January 2024 | Danfoss Climate Solutions for cooling

Cool Update

CTM 6 Multi Ejector – Removal of the DST Pressure Transmitter

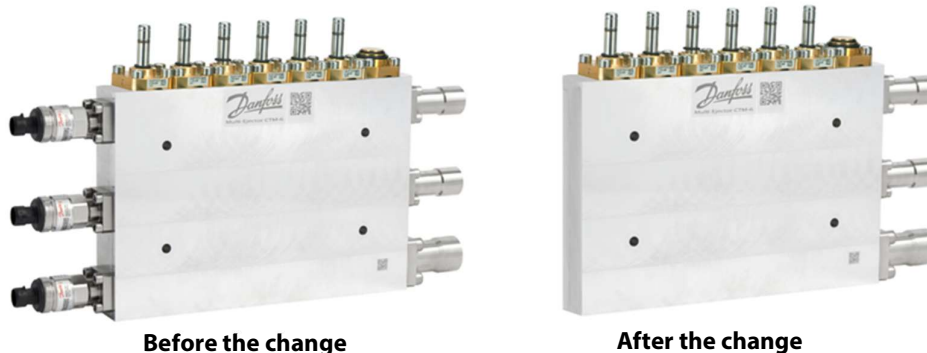
DST P310 pressure transmitters will be removed from CTM 6 Multi Ejectors design.

Danfoss is continuously looking to improve the performance of our products. Recent feedback from our customers show that the pre-installed pressure sensors are almost never used. Therefore, to improve quality and lower our costs, we are removing the pressure sensors from the design.

Pressure transmitter will no longer be part of CTM 6 Multi Ejector design.

An important advantage is less environmental impact – removing difficult to recycle electronic devices and decreasing the weight of the whole product (12 steel screws and sensor mounting plate removed).

Below pictures illustrate the change:

Expected implementation date is February 2024
